# Access Compliance Report

## Public Rights-of-Way

### (Curb Ramps)

Intersection ID: 29557	Main Street: CALABASSAS_LN	Cross Street: BIG_CREEK_CT	Location: SW
ADA ID: BFC2B7F588BB	Ramp Type: PerpDiag	Initial Pass/Fail: Fail	Overall Compliance: No
Severity Score: 21.25			
Codes/Mitigation Info/Possible Solution		Field Measurements/Component Compliance

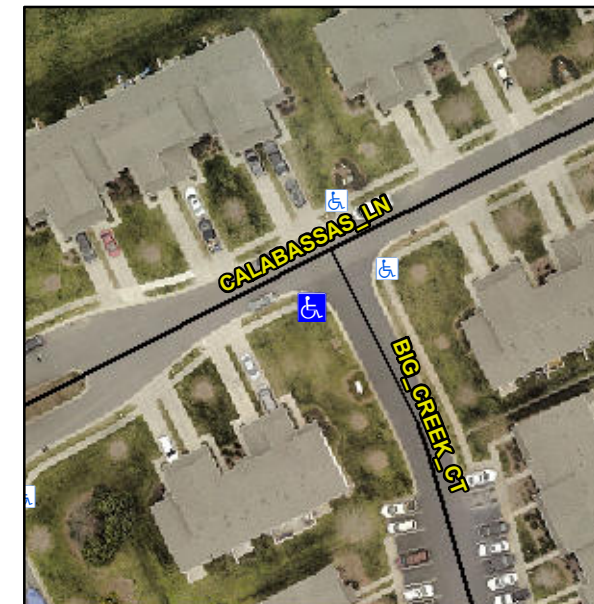
**R304.5.1, R304.2.2**

Compliance	Description	Data	Compliance	Description	Data
N/A	Ramp Length (in)	52.0	No	Ramp Slope (%)	9.4
No	Ramp Width (in)	38.0	Yes	Ramp XSlope (%)	1.5
N/A	Flare Type LT	N/A	N/A	Flare Type RT	N/A
N/A	Flare Slope LT (%)	N/A	N/A	Flare Slope RT (%)	N/A
N/A	Flare Traversable LT?	No	N/A	Flare Traversable RT?	No
N/A	Landing Length (in)	N/A	N/A	DWS Provided?	N/A
N/A	Landing Width (in)	N/A	N/A	DWS Contrast?	N/A
N/A	Landing Slope (%)	N/A	N/A	DWS Length (in)	N/A
N/A	Landing X Slope (%)	N/A	N/A	DWS Full Width?	N/A
N/A	Landing Curb? (Y/N)	N/A	N/A	DWS Offset (in)	N/A
N/A	Shared Landing?	N/A			
N/A	Gutter Ponding?	N/A	N/A	Gutter Slope (%)	N/A
N/A	Gutter Lip Ht (in)	N/A	N/A	Gutter X Slope (%)	N/A
N/A	Painted X Walk1?	No	N/A	Painted X Walk2?	No
	X Walk 1 Direction	To E		X Walk 2 Direction	To N
N/A	X Walk 1 Width (in)	N/A	N/A	X Walk 2 Width (in)	N/A
	X Walk 1 Slope (%)	1.3		X Walk 2 Slope (%)	5.4
	X Walk 1 X Slope (%)	5.9		X Walk 2 X Slope (%)	1.8

**Remove & Replace Curb Ramp With Two New Directional Ramps or Equivalent.**
